Subject: **Response to Portion of NRC Request for Additional Information Letter No. 66 Related to ESBWR Design Certification Application – TRACG Application for Pressurization Events – RAI Numbers 21.6-56, 21.6-58 and 21.6-59**

Enclosure 2

TRACG Application for Pressurization Events

RAI Numbers 21.6-56, 21.6-58, 21.6-59

Figure 21.6-56-1. GE14 Pressurization Event without Recirculation Pump Trip (Run 1412)

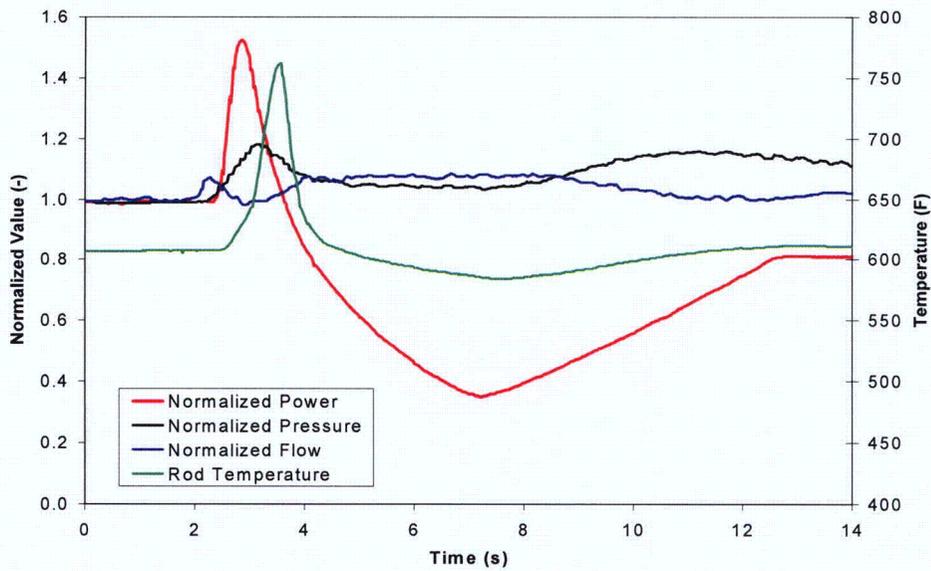
GEXL is a quasi-steady-state boiling length correlation, which is used in TRACG to predict the critical power ratio (CPR). Provide the basis for using a boiling length quasi-steady-state correlation for rapid pressurization transients, such as load rejection with no bypass (LRNB).

Specific comparisons with TRACG and GEXL for rapid pressurization transients are discussed below. Tests were performed in the ATLAS test facility simulating the pressure, inlet flow and heat flux for typical pressurization transients. Figure 21.6-56-1 shows the transient parameters for a typical test. Tests were performed by increasing the initial power in small increments until a boiling transition occurred during a test. This implies that the minimum CPR in the transient was 1.0. The experimental Δ CPR for the test can then be determined based on the initial CPR at the start of the transient. The experimental Δ CPR is then compared with the Δ CPR calculated for the transient with TRACG and the GEXL correlation. Figure 21.6-56-2 shows a comparison for five pressurization transient tests performed with rod bundles simulating GE-9, GE-11 and GE-14 fuel types. It is evident that the agreement between data and calculations is excellent.

Figure 21.6-58-1: Effect of Time Step Size on Steam Dome Pressure Response for Pressurization Transient

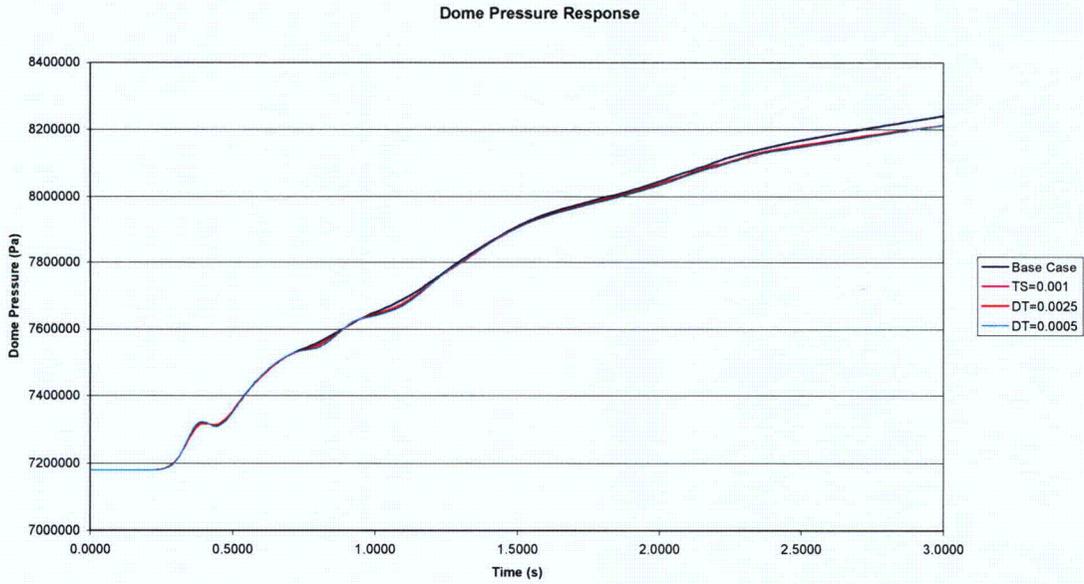
A two-fluid finite difference donor cell model with a relatively coarse noding such as that implemented in the TRACG methodology tends to smear out or diffuse pressure waves. Explain how this numerical diffusion of the pressure wave has been quantified and factored into the TRACG uncertainty analysis for the rapid pressurization events.

The results are shown in Figures 21.6-58-1 and 21.6-58-2 for the pressure and power response, respectively. There is almost no effect of time step size in the range of sensitivity studies. The time step and nodalization used in the base case in the DCD are adequate

Figure 21.6-59-1: Pressure Response for Peach Bottom Turbine Trip Tests

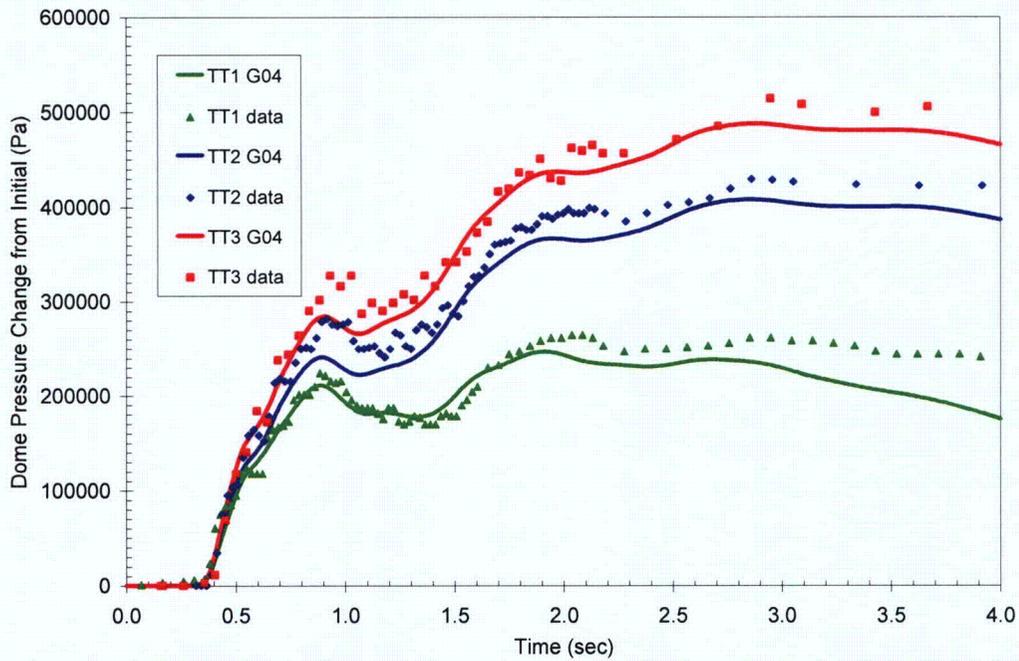
Provide additional information demonstrating that TRACG is capable of calculating the propagation of a pressure wave through a two-phase mixture. Identify the assessment calculations in which this is demonstrated.

Details of the TRACG qualification studies for these tests can be found in the TRACG Qualification Report [NEDE-32177, Rev. 2 or Rev. 3]. The key comparisons are shown in the attached figures. Figure 21.6-59-1 shows the short-term pressure response. The effects of the steamline dynamics are evident in the pressure response. The turbine stop valves close at time zero on the plot. The pressure wave reaches the steam dome at approximately 0.35 s, when it starts to pressurize. The pressure trace reflects the effects of acoustic wave reflections from the steam dome and the stop valve. TRACG predicts the start of pressurization and the pressure rate accurately. The timings of the inflection points indicating acoustic wave reflections are also predicted accurately. This confirms the adequacy of the TRACG model and nodalization to capture the acoustic wave phenomena in the steamlines.
